Access Compliance Report Public Rights-of-Way (Curb Ramps)

Main Street: SANTA_CLARA_AVE		Cross Street: LAURINDA_WAY		Location:	NW
ADA ID: RPAT211019093147	Ramp Type: Type 4 - Parallel	Initial Pass/Fail: Fail	Overall Compliance: No	Severity Score:	15
Codes/Mitigation Info/Possible Solution			Field Measurements/Component Compliance

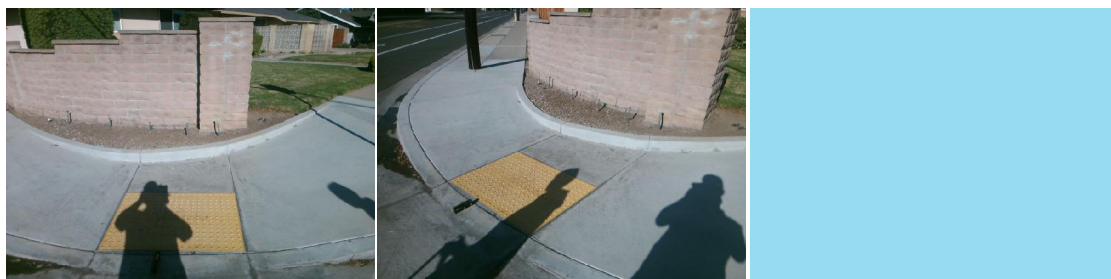
Compliance	Description	Data	Compliance	Description	Data
N/A	Ramp Length LT (in)	94	N/A	Ramp Length RT (in)	116
Yes	Ramp Width LT (in)	68	Yes	Ramp Width RT (in)	82
Yes	Ramp Run Slope LT (%)	7.1	No	Ramp Run Slope RT (%)	8.9
Yes	Ramp Cross Slope LT (%)	1.5	Yes	Ramp Cross Slope RT (%)	1.2
N/A	Landing Present	N/A	N/A	DWS Provided	N/A
N/A	Landing Length (in)	N/A	N/A	DWS Contrast	N/A
N/A	Landing Width (in)	N/A	N/A	DWS Length (in)	N/A
N/A	Landing Run Slope (%)	N/A	N/A	DWS Full Width	N/A
N/A	Landing Cross Slope (%)	N/A		DWS Offset Type	N/A
N/A	Landing Movement Obstructed?	N/A	N/A	DWS Offset Left (in)	N/A
	Landing Movement Type	N/A	N/A	DWS Offset Right (in)	N/A
N/A	Landing Shared	N/A			
N/A	Clear Space	Yes			
N/A	Clear Space To Crosswalk (in)	N/A			
N/A	Marked Crosswalk 1	No	N/A	Marked Crosswalk 2	No
	Crossing 1 Direction	S		Crossing 2 Direction	E
	Marked Crosswalk 1 Width (in)	N/A		Marked Crosswalk 2 Width (in)	N/A

Remove & Replace Curb Ramp With Two New Directional Ramps or Equivalent.

R304.3.2, STD 1115
